# M1 Pacific Motorway extension to Raymond Terrace

## Submissions Report

June 2022

Date: 5/04/2022 Path: I:\jacobs.com\ANZ\3E\Projects\04\_Eastern\A23000022\_Spatial\GIS\Directory\Templates\Figures\Submissions\_Report\A230000\_CD\_SubReport\_001\_ProjRefinements\_JA\_C\_A41\_R250\_V05.mxd

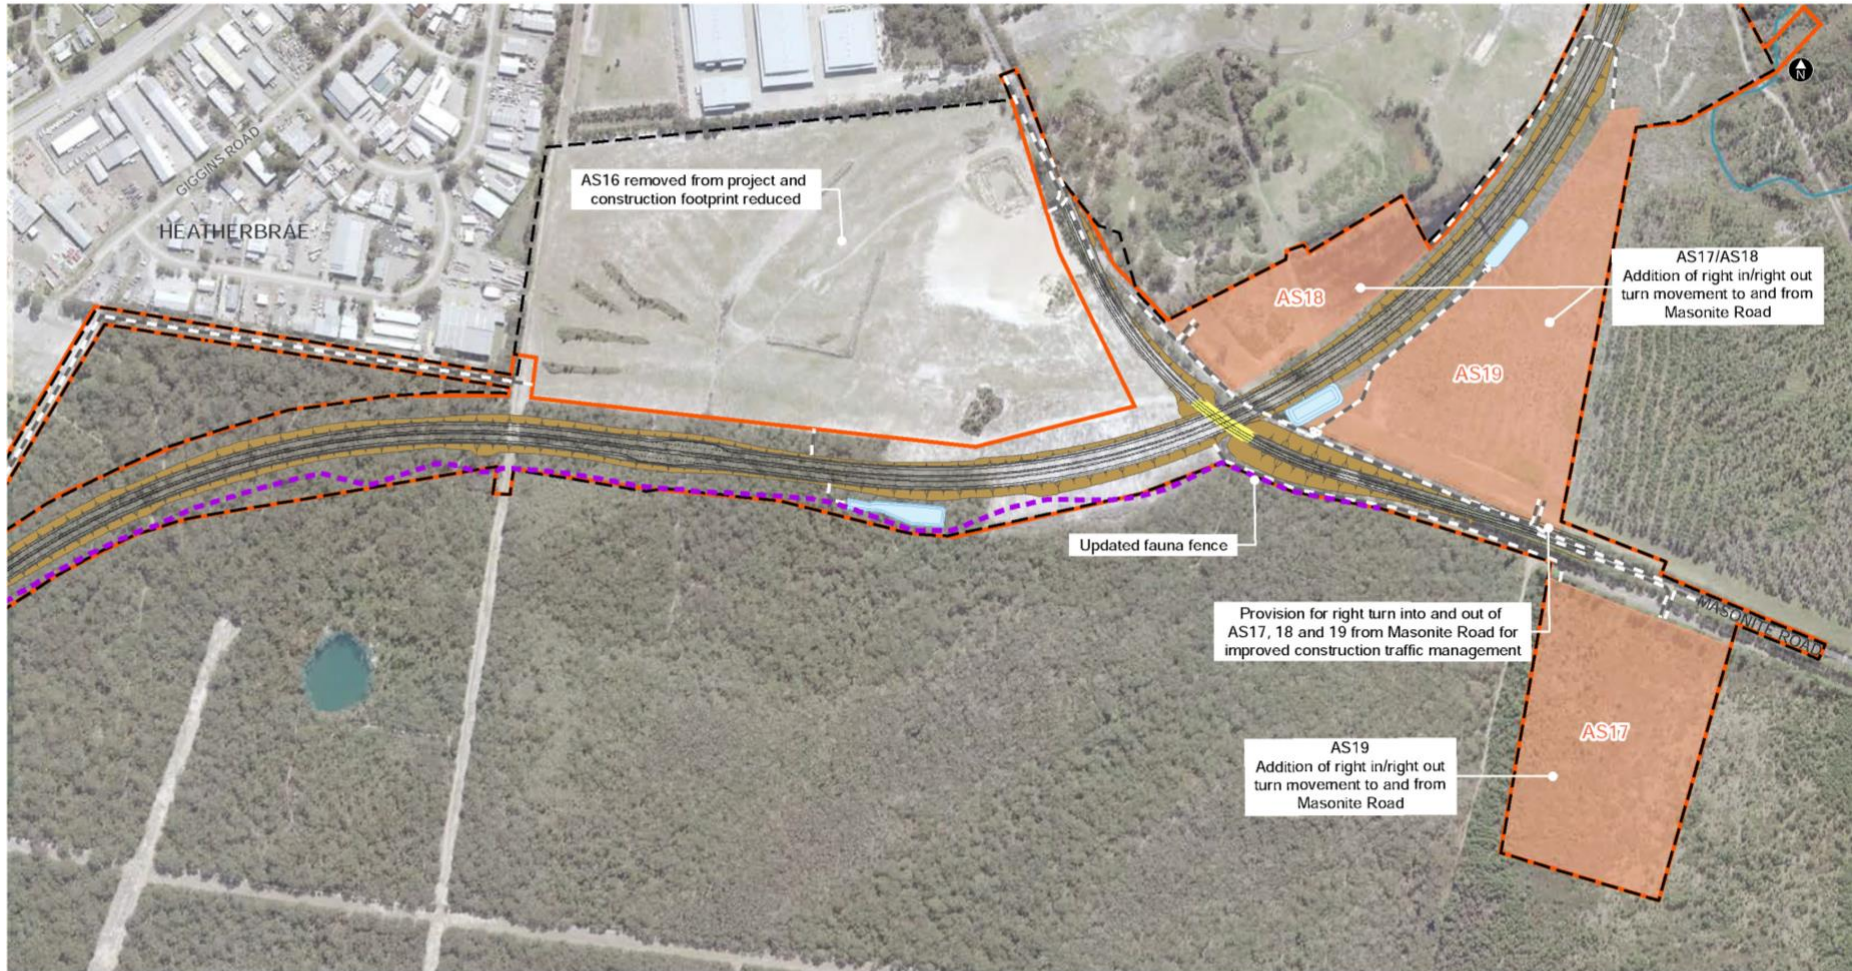
The southbound M1 Pacific Motorway merge lane for traffic from the John Renshaw Drive/Weakleys Drive intersection has been extended by about 200 metres to allow for improved merging (refer to **Figure 5-1**). The merge lane extension includes minor widening to the existing M1 Pacific Motorway southbound carriageway and relocation/replacement of the existing adjacent noise wall at this location.

- Grouping of utilities at Tarro and Tomago into 12 metre wide multi-utility corridors:
  - Tarro (refer to **Figure 5-1**) - the multi utility corridor would be about 1.9 kilometres long and generally aligned east-west along the southern side of the main alignment and Tarro interchange. This would require a small increase to the construction boundary at this location.

The construction footprint has been reduced by 1.5 hectares on the western side of the existing M1 Pacific Motorway at Black Hill (refer to **Figure 5-1**). This area forms part of the road reserve and consists of native vegetation that provides koala habitat. This boundary refinement reduces the project impact on koala habitat and has been in response to the DPIE - BCD submission.

The construction and operational project boundaries have been reduced on the southern side of the main alignment south of Old Punt Road (refer to **Figure 5-1**). The minor boundary reduction at this location was made following consultation with the landowner AGL. The boundary refinement reduces property impacts on AGL land and ensures adequate provision for both the project and AGL's approved gas fired power plant project.

**Figure 6-1** Update of Local Catchment Hydrologic Modelling

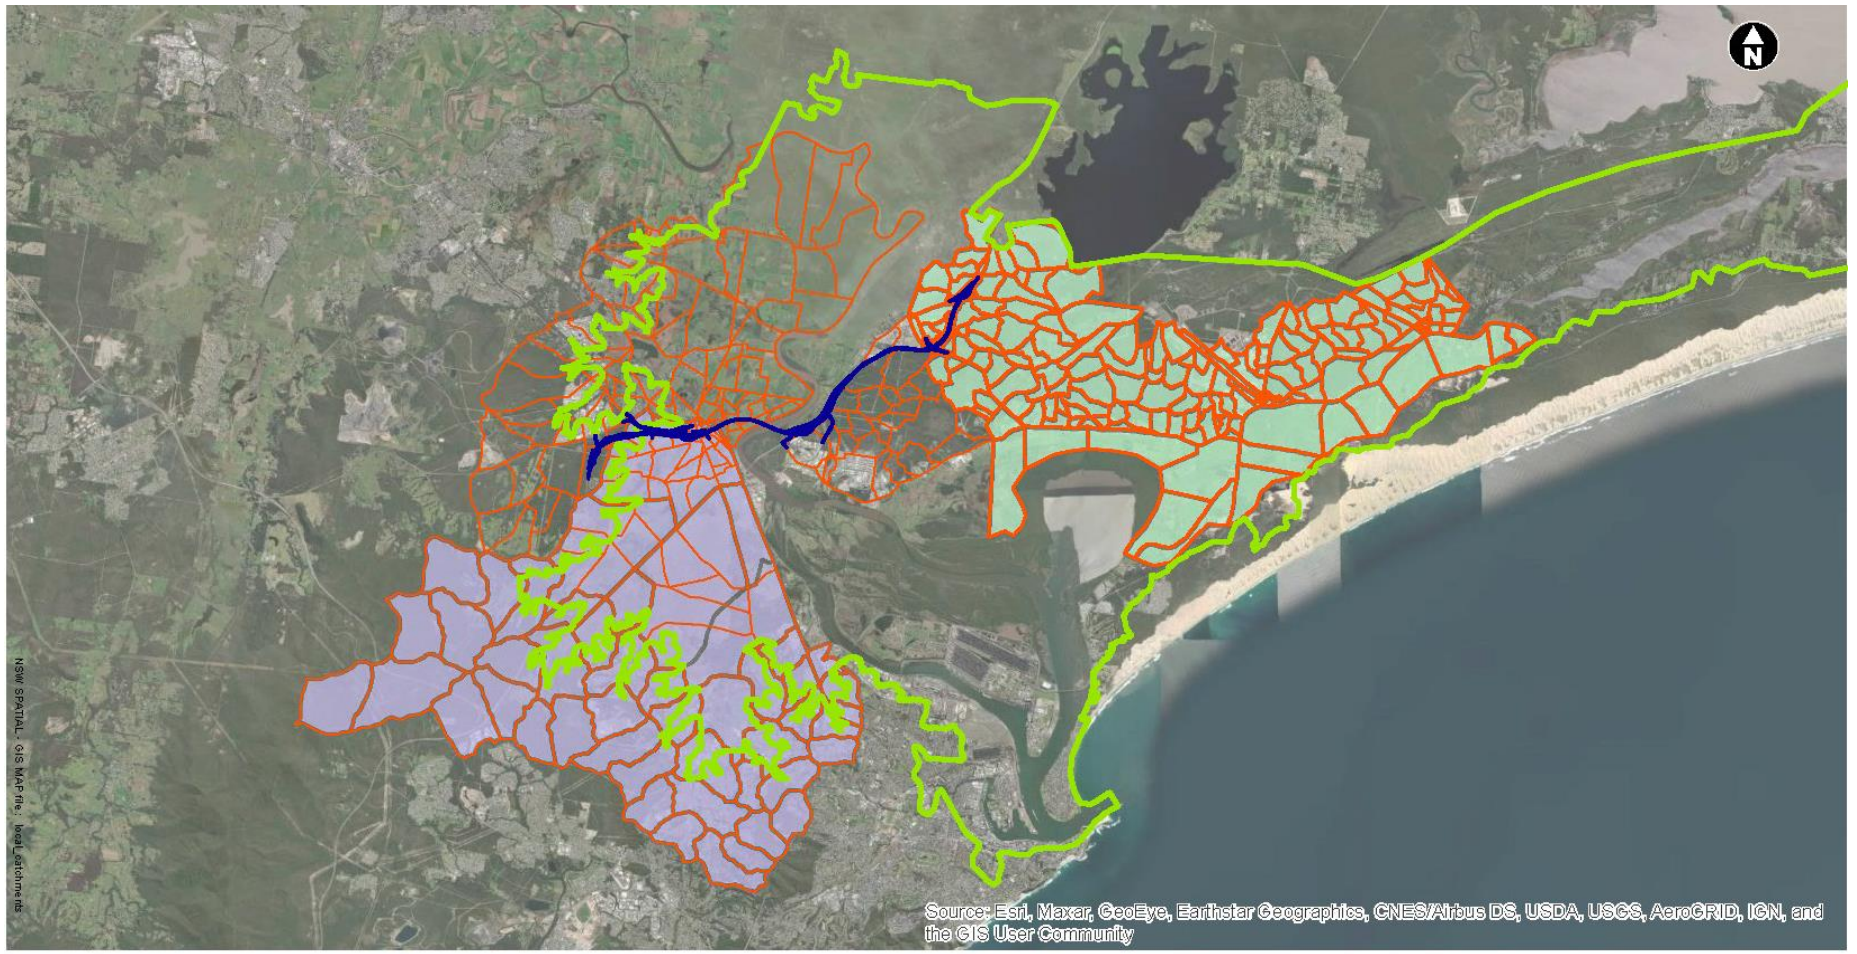
Additionally, the flood extents of the model in the EIS and the supplementary report were challenged as the afflux conditions on the edge of the modelled area where above the assessment criteria (10 millimetres) recommended for the assessment. This resulted in additional modelling being undertaken to determine the project impacts in the upper reaches of the Hunter and Williams River beyond the extent of the existing *Williamstown – Salt Ash Floodplain Risk Management Study and Plan modelled* area used for the project. This assessment was undertaken and is provided in **Appendix G**. The outcome of this investigation was that there were no new above floor flooding upstream in either catchments in the 1% AEP, as a result of the project.

The original modelled sub-catchments and updated model sub-catchments are shown on **Figure 6-1**. Sub-catchment delineation, areas and slopes were determined from LiDAR topographic data.
